LLANDOVERY DEVELOPMENT ENVIRONMENTAL IMPACT ASSESSMENT ADDENDUM

ENVIRONMENTAL IMPACT ASSESSMENT - ~~A~~DDENDUM

Addendum III – Revised Drainage Plan

Revision #1

PROJECT	
FLAT POINT, LLANDOVERLY, ST. ANN	
CLIENT	
LIFE OF JAMAICA	
TITLE	
DRAINAGE LAYOUT PLAN	
DESIGNED BY	APPROVED BY
AF/D.E.N.	AF.
DRAWN BY	CHECKED BY
D.E.N.	AF.
DATE	SCALE
NOV. 2007	1:500
PROJECT NUMBER	
0740/241/S	
SHEET NUMBER	
0-01c

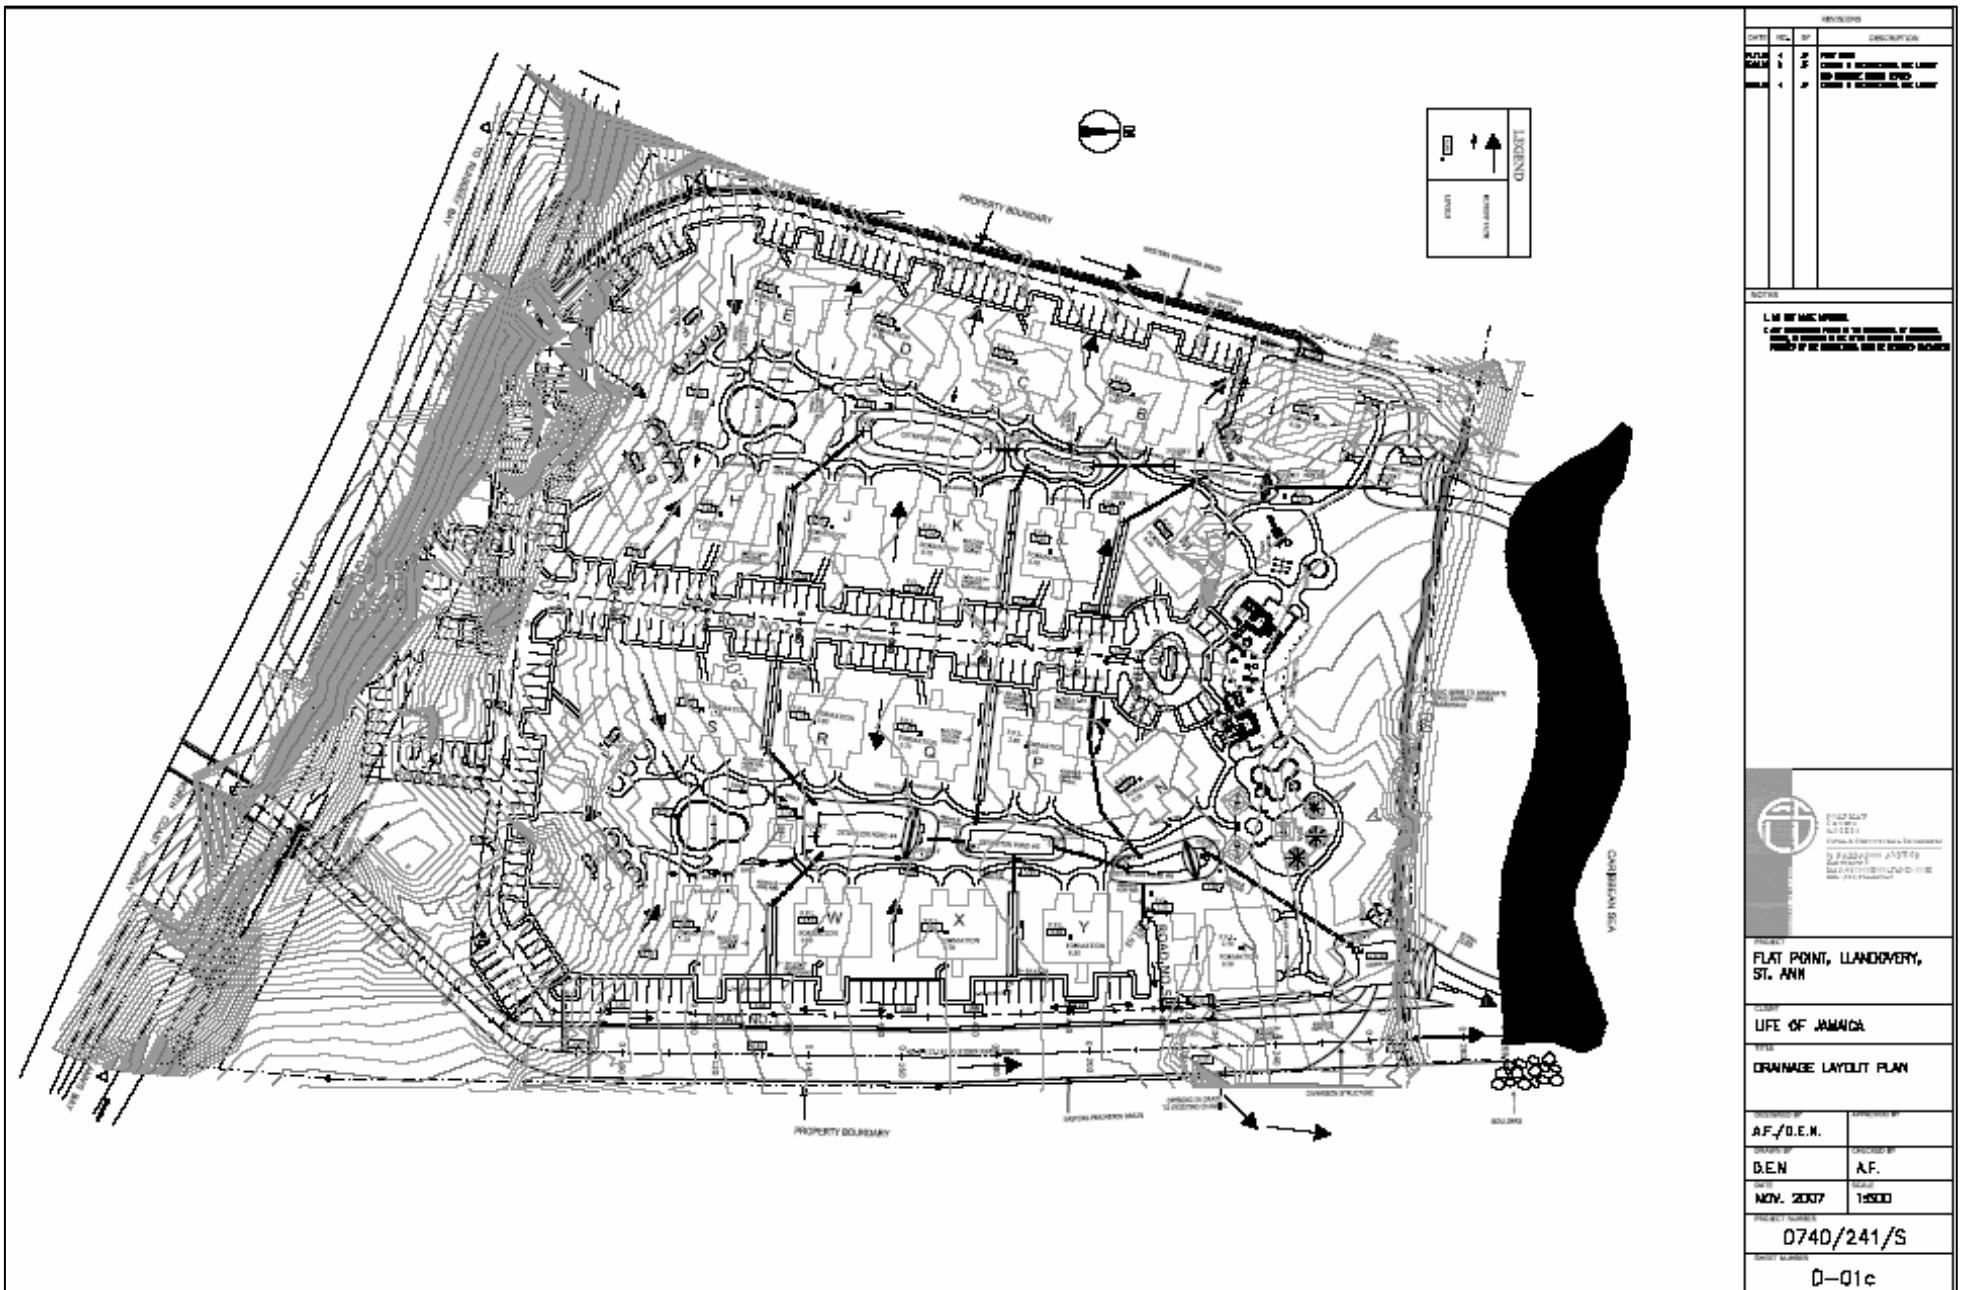
Following the release of the updated engineer’s report dated July 2008 (Document No. 0741/241/S Revision#1) the following serves to update the information in the main hydrologic assessment.

4. The report further states that internal drainage will be handled by two drainage systems that consist of conventional drainage techniques along with earth swales and other detention areas

prior to discharge to sea. The internal drainage will be distinct and separate from the proposed Flat Point River drainage corridor through the property.

PROJECT	
FLAT POINT, LLANDOVERLY, ST. ANN.	
SITE	
LIFE OF JAMAICA	
PROFILE	
PROFILE ALONG CENTRELINE OF EAST DRAIN	
DESIGNED BY	APPROVED BY
A.F.	
DRAWN BY	CHECKED BY
D.E.H.	A.F.
DATE	SCALE
JULY 2008	1:500
PROJECT NUMBER	
D74D/241/S	
SHEET NUMBER	
D-02a

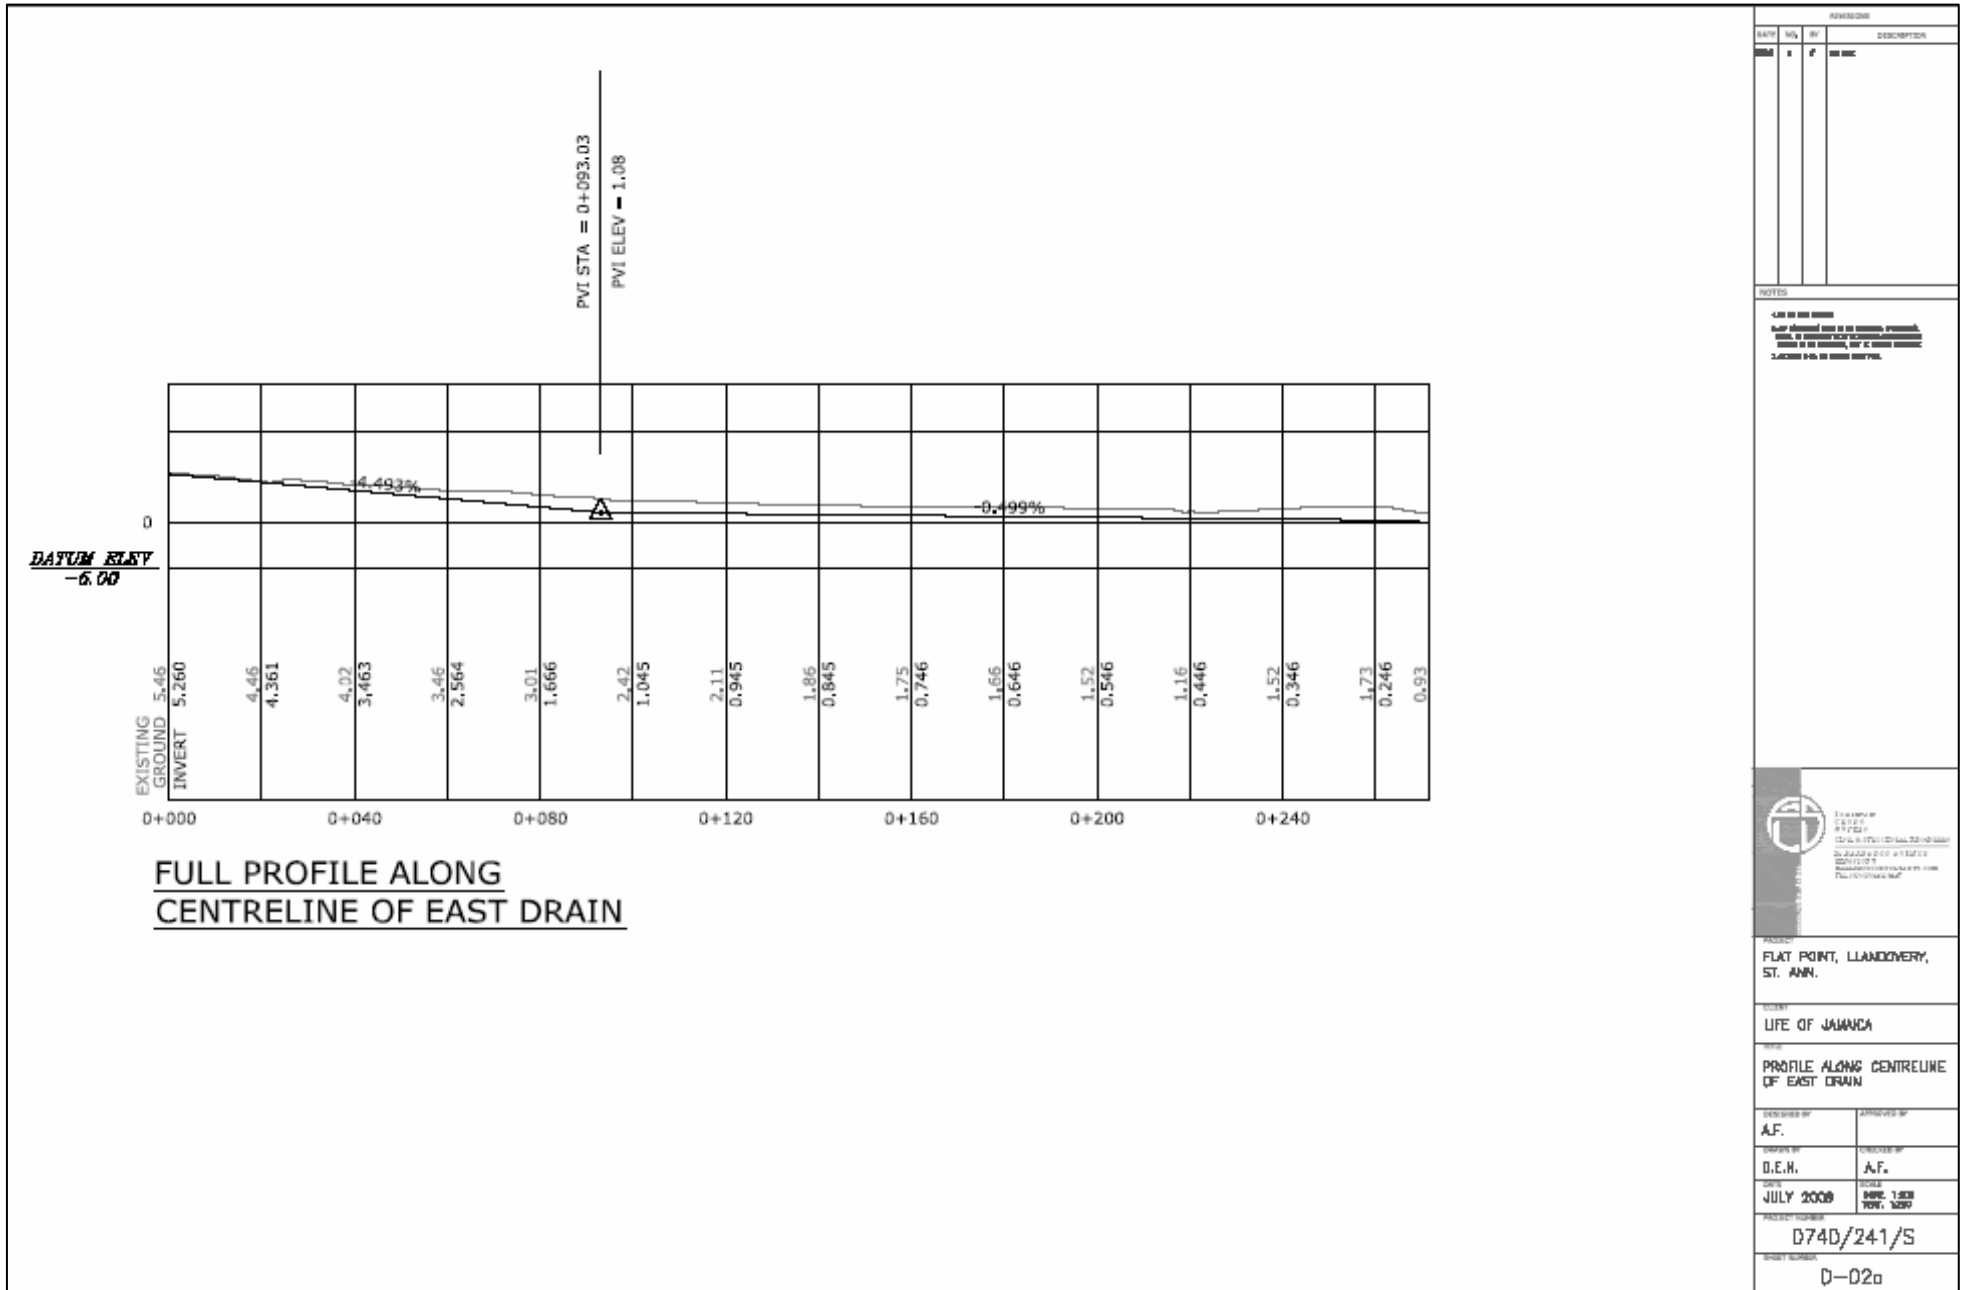
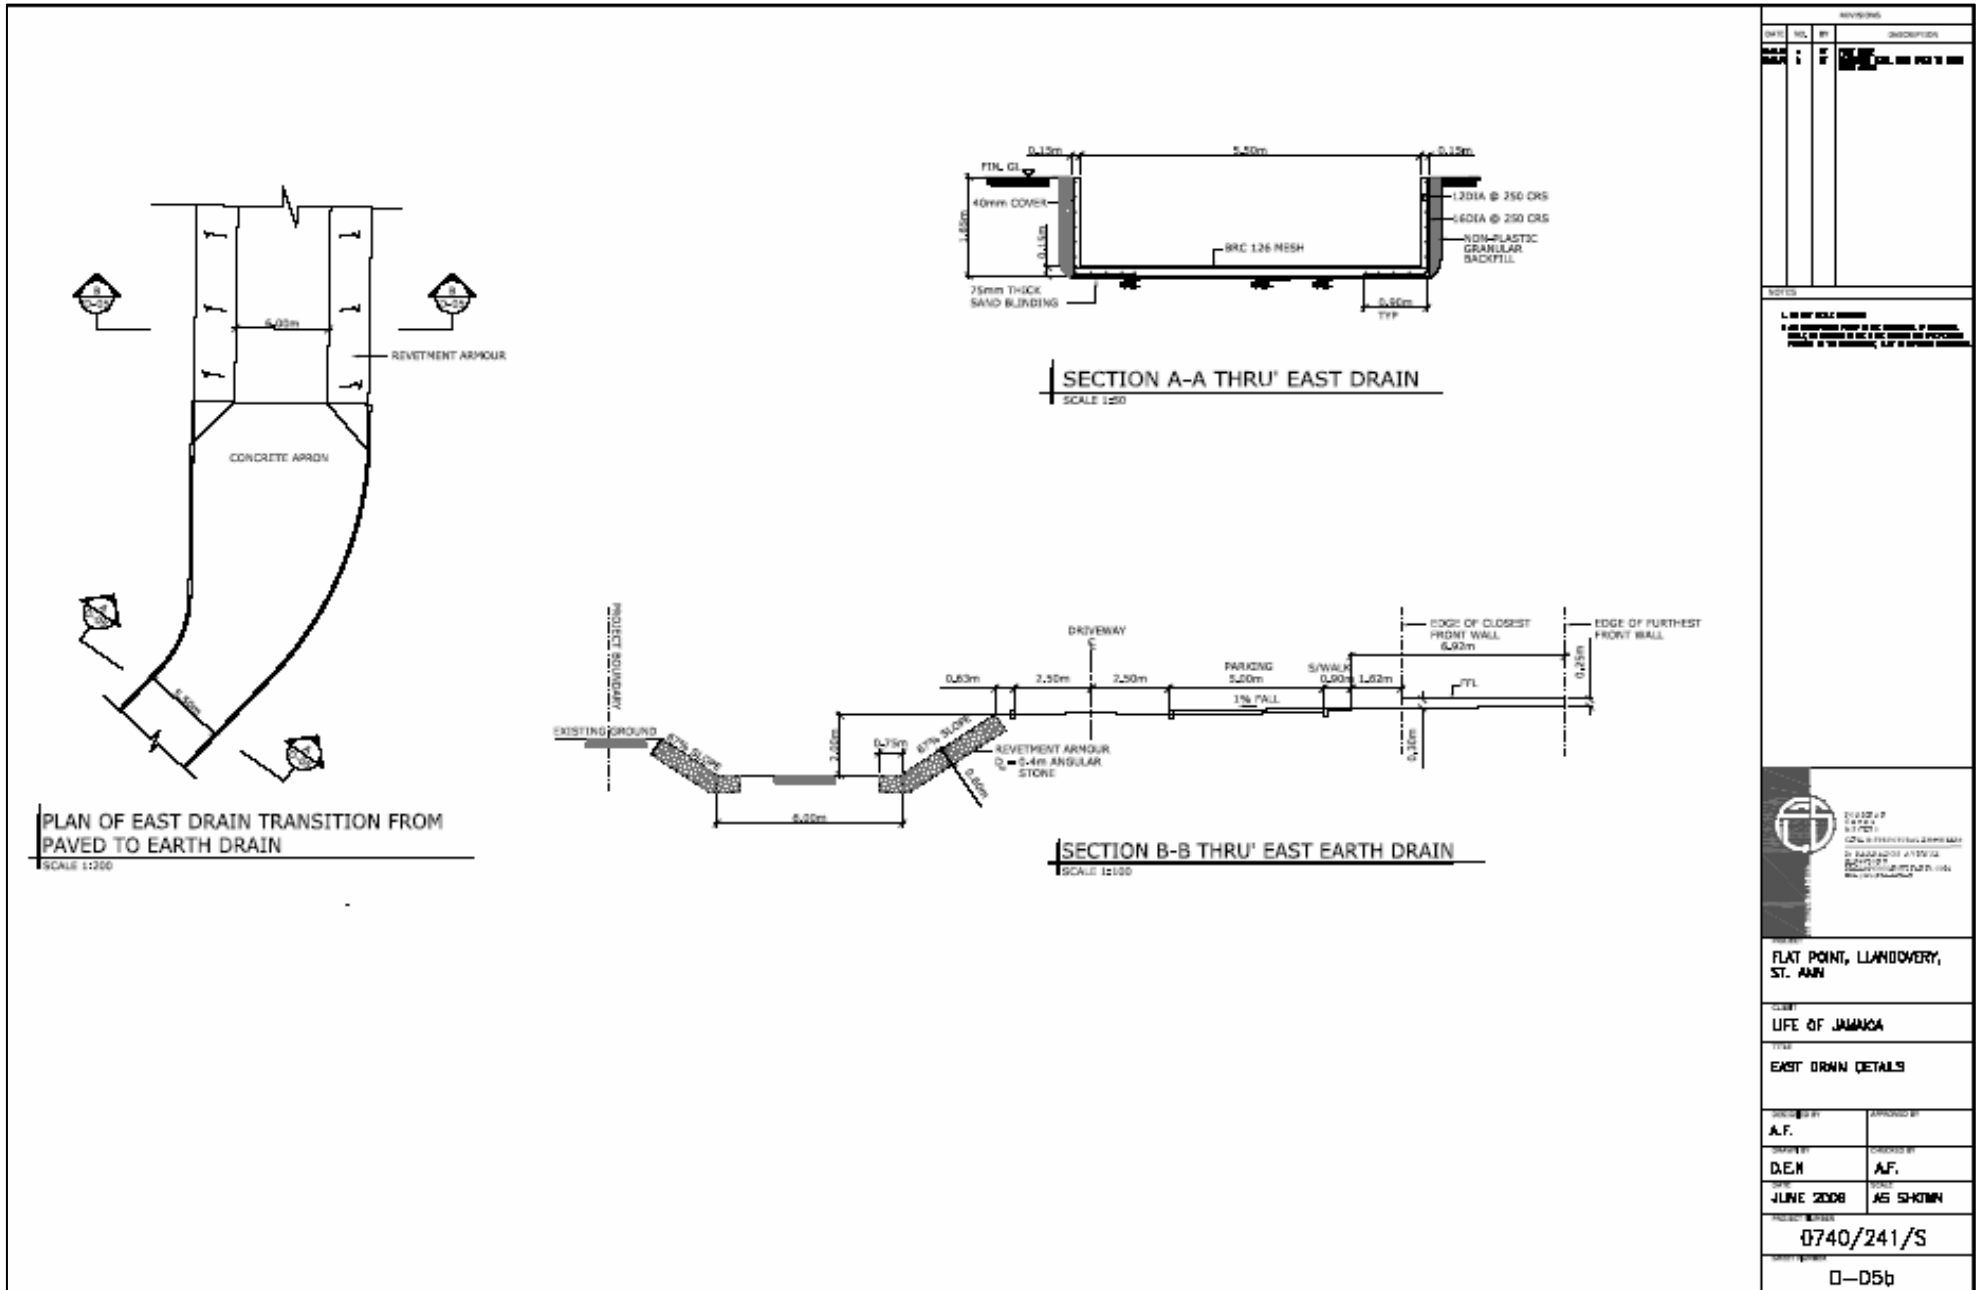
2. Additionally, the engineer’s report has done an evaluation of the capacity of the proposed drain to accommodate the predicted peak flows and each scenario indicates that the drains capacity will be able to accommodate the proposed flows with some freeboard. The requirement to have the drain cleaned annually will reduce the accumulation of debris and hence keep the proposed drain at its intended design capacity. Given the predictions that all the predicted flow will be contained within the proposed drains with freeboard the requirement for a flood assessment was not deem necessary by the engineers.

5. A 12m wide strip of land has also been reserved to the eastern boundary of the property to convey any infrequent storm events into the sea.
